City of Jefferson

RE: Response to letter received May 18, 2015 regarding sewer permit authority
MO-0094846 & MO-0044300

The following is a response to the review letter provided. The numbered responses correspond to the numbered comments.

**OUTSIDE FOULWATER
DROP MANHOLE**

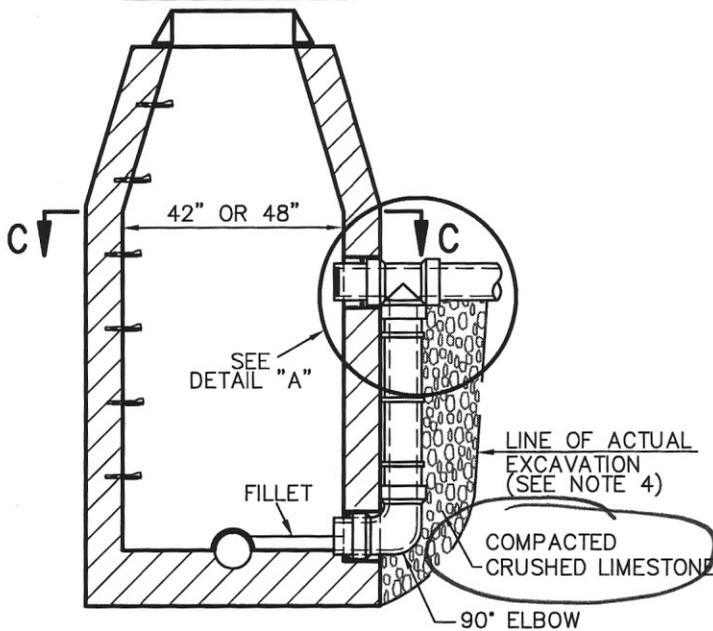
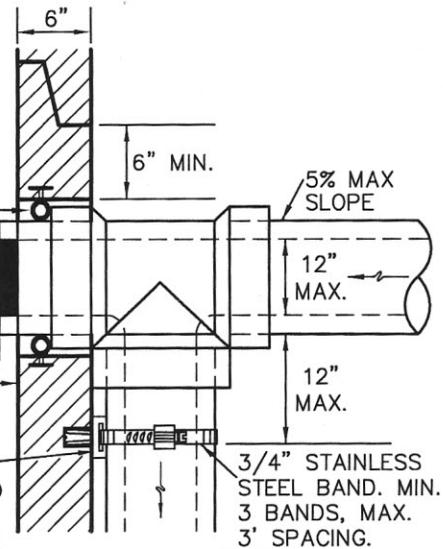
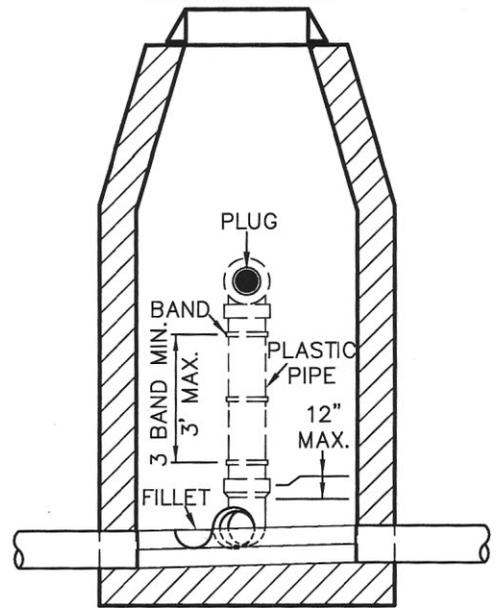
The Jefferson City service area features hilly terrain so there are many drop connections in the current system and proposed each year. We also feel validated to our approach as Metropolitan St. Louis Sewer District uses a similar concept (detail attached).

The reason that a drop connection backfilled in crushed aggregate is more successful than one encased in concrete is that the rest of the excavated areas are generally not compacted optimally. Aggregate can transfer weight and fill voids in the surrounding area, while the poorly supported concrete can only move as a complete unit into settled areas a void creates.

The aggregate is also more resilient to variable water table. If concrete is poured in a wet condition, it will move toward settlement if the trench later dries out.

Since 2007 there have been over 53 drop manholes installed using crushed aggregate to support the drop and there have been no failures. From 1979-2007 there were over 15 drop connections that failed, prompting us to use the aggregate supported method.
